STAFF REPORT: NOVEMBER 12, 2025 MEETING

APPLICATION NUMBER: HDC2025-00249

ADDRESS: 6325 W. JEFFERSON AVENUE, AKA FORT WAYNE

SCOPE: REPLACE HISTORIC FENCE, RENOVATE PRIMARY ENTRANCE, SITE IMPROVEMENTS, REPLACE PARK SIGN

Staff photos, July 17, 2025.

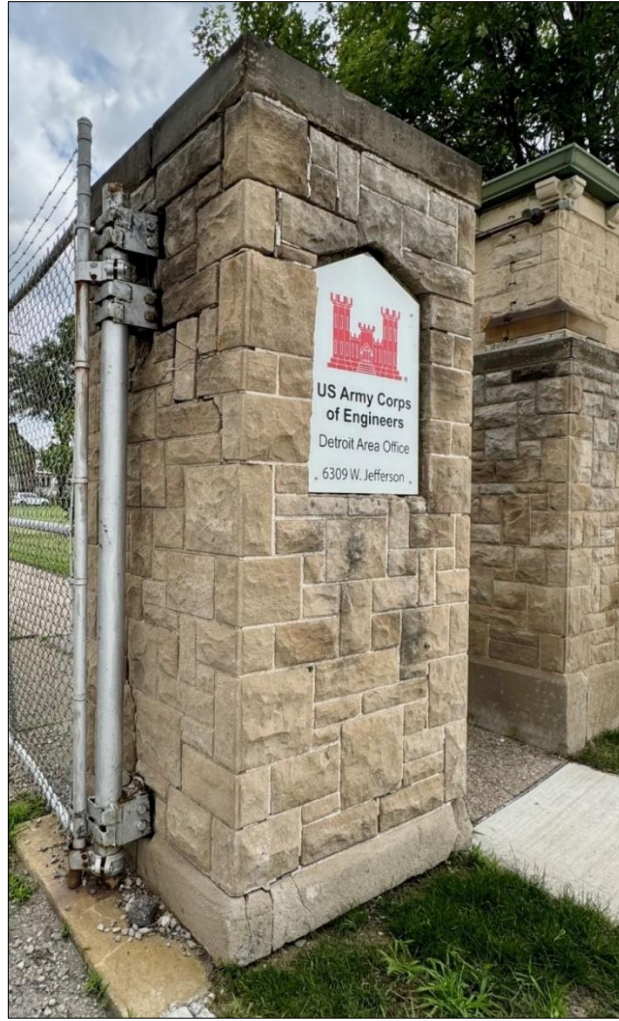
- Each pier has areas of missing mortar, cracked, dirty and/or stained stone. The applicant’s drawing, specifically Page A1.0, states the masonry cleaning and repointing of all failed masonry mortar joints will be consistent with the NPS briefs: “Cleaning and Water-repellent Treatments for Historic Masonry” and “Repointing Mortar Joints for Historic Masonry Buildings.”

Below: Applicant drawing of proposed gate. This drawing is for reference only as it doesn't show installation at either entrance's stone piers, nor does it list the specific dimensions for installation. Color: black.

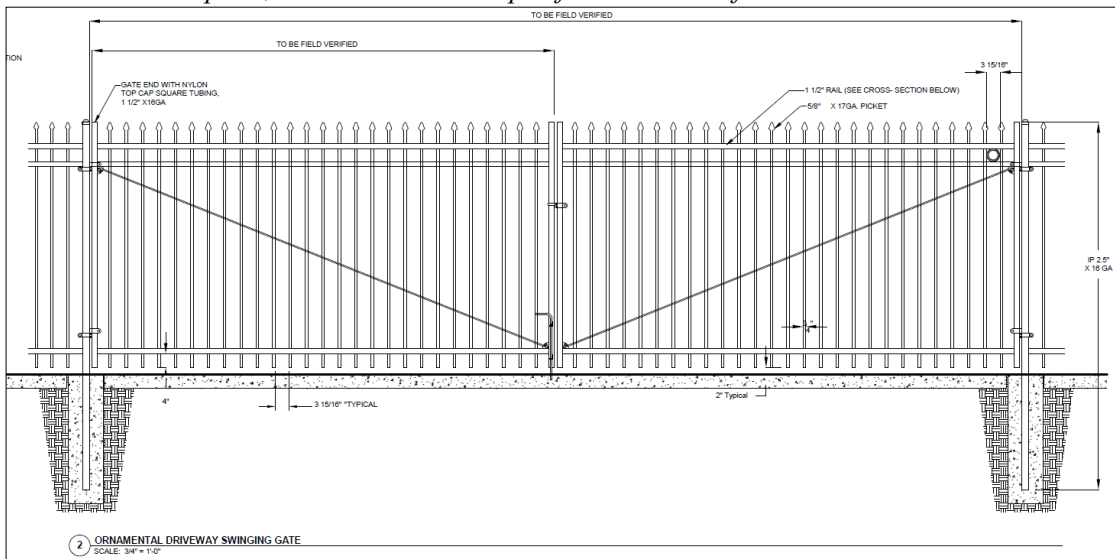
- The existing chain link gates are not historic age and can be replaced. The selected iron gates offer a compatible design, material and color for this primary entrance. However, an installation drawing for the proposed iron gates is needed to confirm that additional holes will not be created to hang the new gates.

Above: The entry gate piers and sentry house have areas of missing mortar, cracked and discolored stone, as well as existing holes used for the installation of the chain link gates. Staff photos, July 17, 2025.

- Dimensioned drawings for the proposed gates at the east and west entrances will be submitted to accurately reflect their installation methods and locations at the stone piers.
 - Additional holes will not be created to hang the new gates, and
 - The drawings should show how any remaining holes will be addressed relative to the gate installations.
- Regarding masonry cleaning, the applicant/contractor will also follow the HDC *Masonry Cleaning Guidelines* and a detailed scope of work, as identified in the guidelines, will be submitted to staff for review and approval prior to work taking place.

Guard House

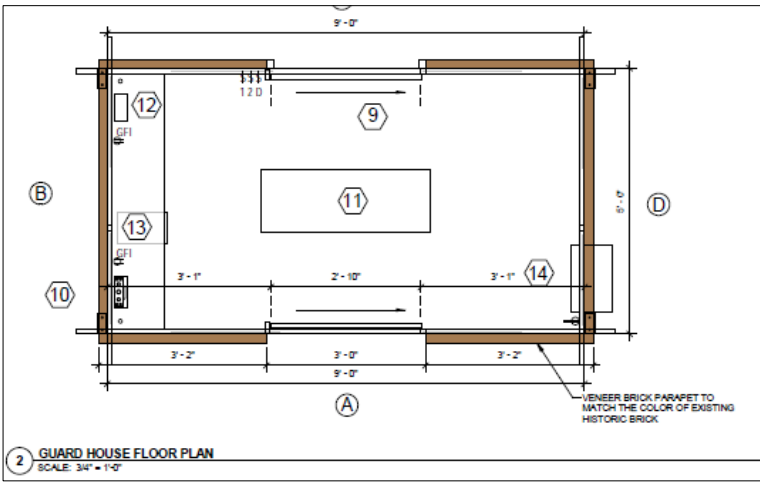
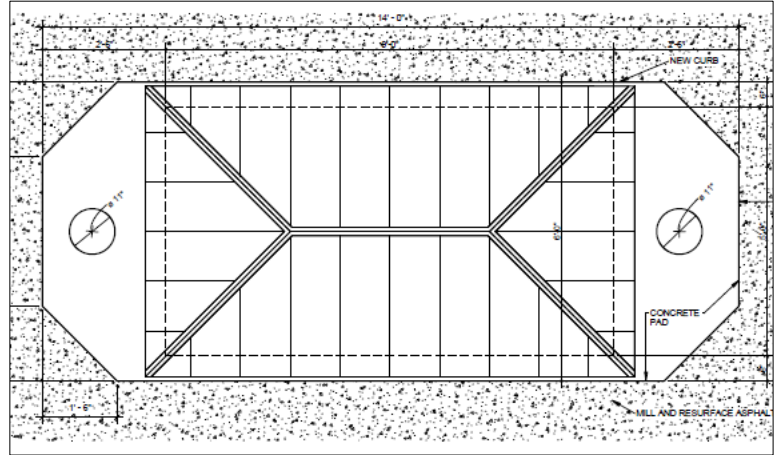
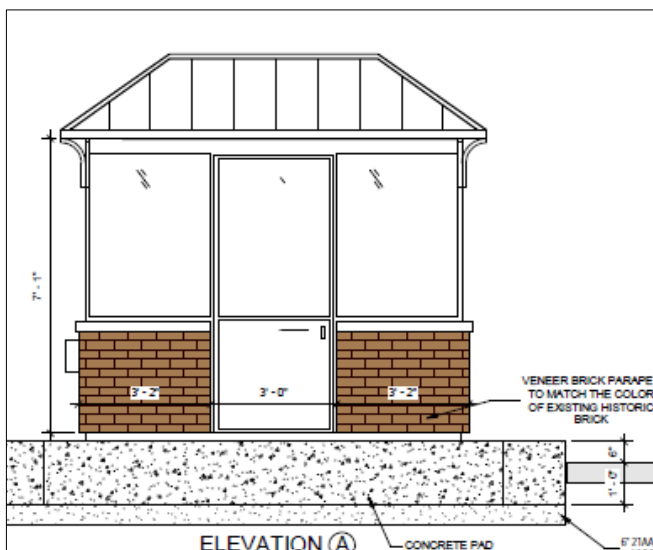
- The existing guard house, pictured below, was likely erected in the late 1990s or early 2000s as the location was moved to the center of Brady Street. The previous guard house had been placed in the lawn area, close to where the arrow is positioned. This guard house has no historic significance and can be replaced.
- The new guard house will be in the same location and will rest on a similarly designed/sized concrete pad with a bollard at the front and rear walls. Its design is similar to the existing structure - the brick base, mostly transparent glass upper walls and metal hip roof is a compatible, unadorned utilitarian design that will not visually conflict with the surrounding historic masonry structures.

Below left: Elevation drawing of the east or west wall. Note states: "Veneer brick parapet to match the color of existing historic brick."

Removal of existing sign and flags /
Installation of new sign and flags

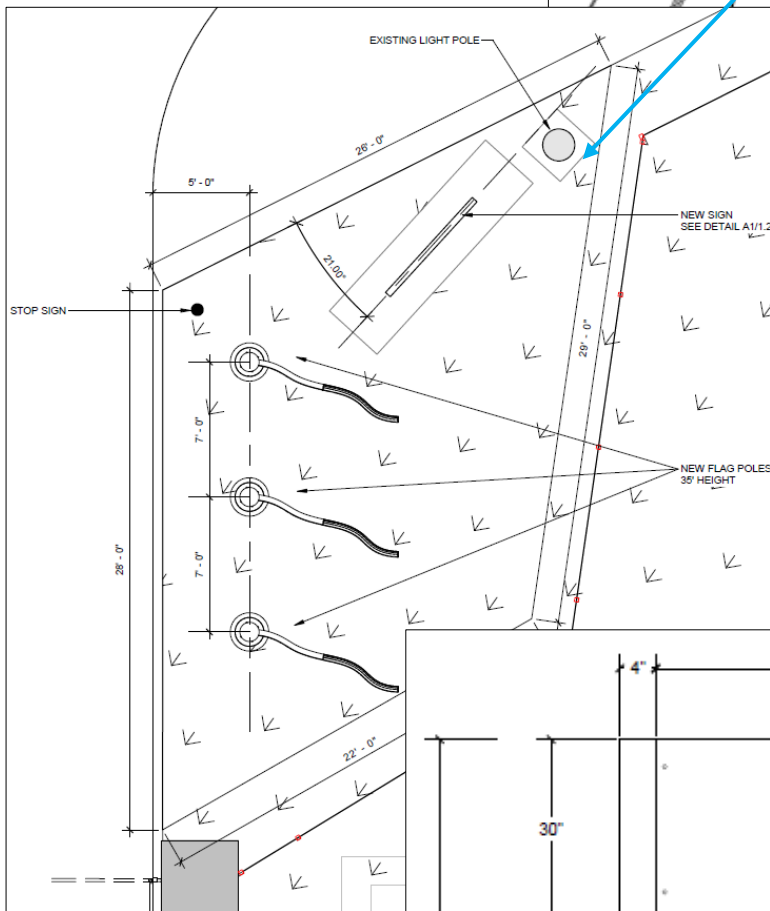
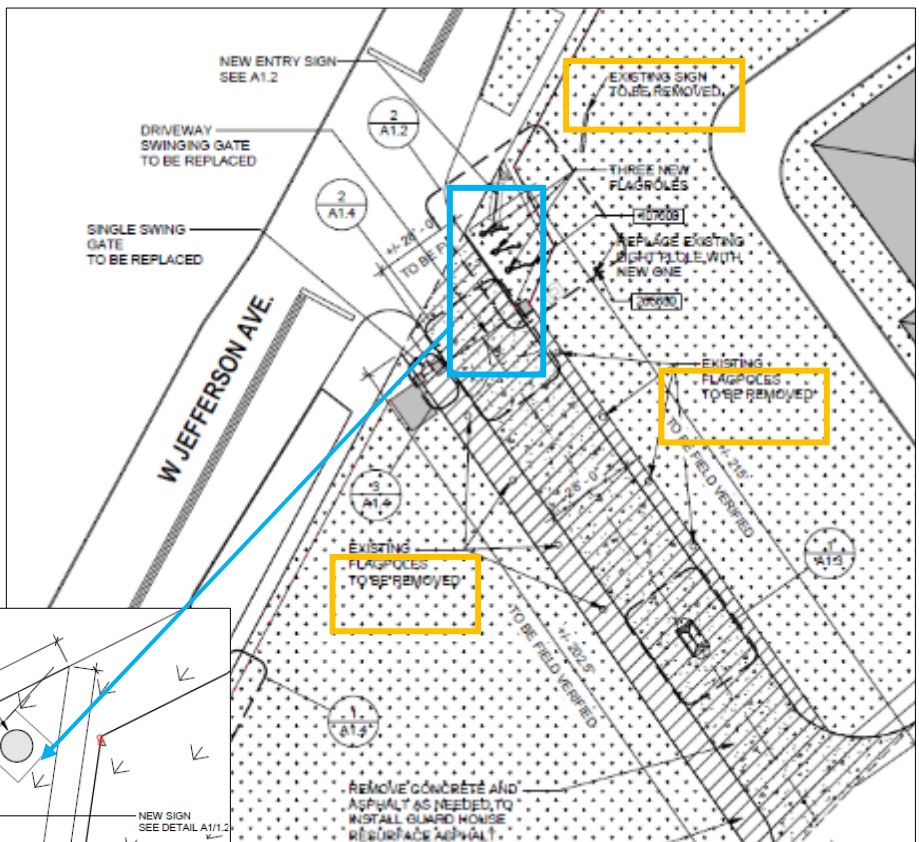
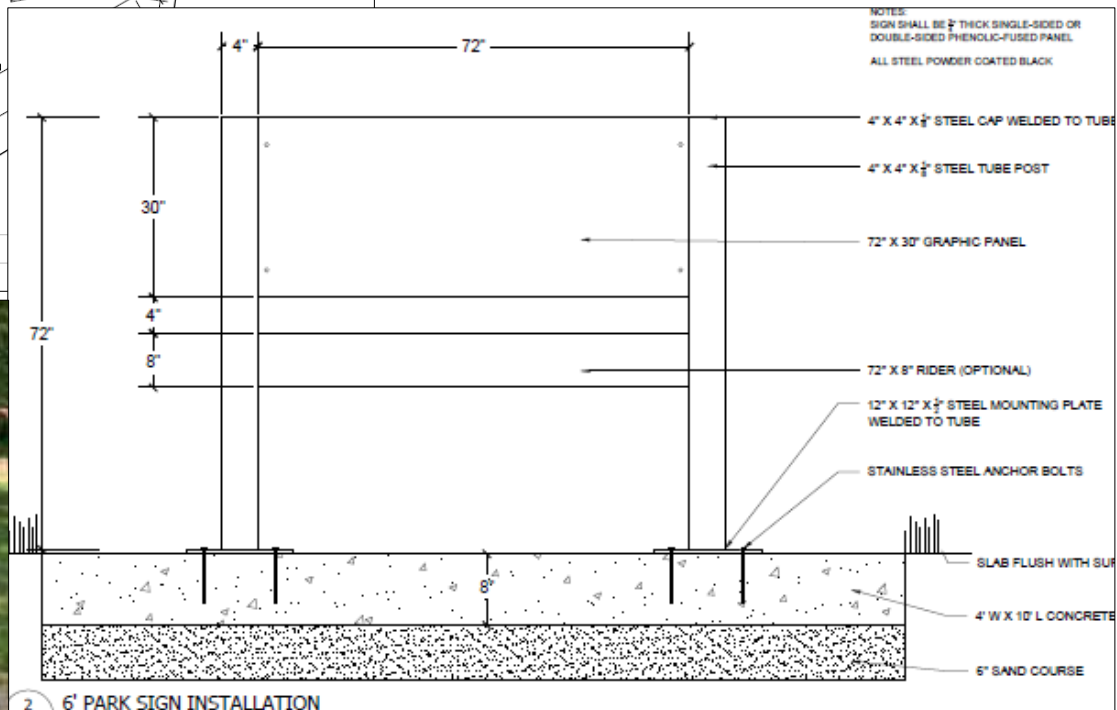
- The existing flag poles, flanking Brady Street will be removed. They are not historic age and were installed in the late 1970s-early 1980s.
- The existing entrance sign, installed ca. 1984, will be removed.
- The concrete drive and walkways will be replaced with new concrete drive and walkways.
- A new sign and set of three (3) flags will be located outside the entrance and perimeter fence.

Existing conditions of fence

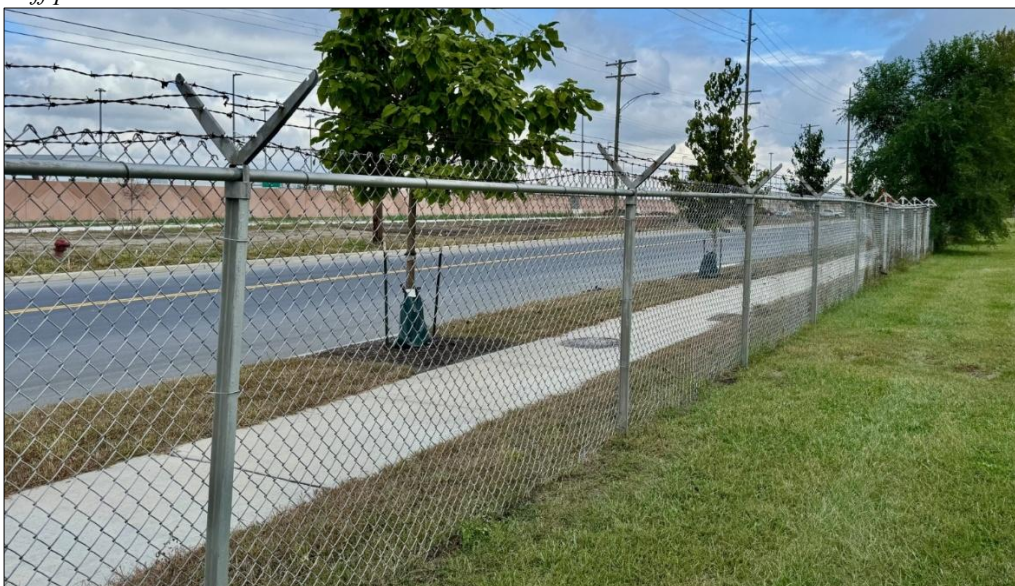
Interior view (looking northeast towards W. Jefferson) of the 1860s entry walls shows how the non-climbable fence was installed on top of the stone walls at the east entry gate, and the existing chain link gate retains barbed wire at the top. Staff photo, July 17, 2025.

Fence between Cram and Brady streets; the visitor parking lot is visible through the fence.

- However, there are occasional areas where the fence needs attention due to missing or leaning posts, as well as one instance in which a tree grew into and ultimately around/through the fence. Also, some of the toppers have surface rust, which could be eliminated by gentle surface repairs/scribbling/refinishing.
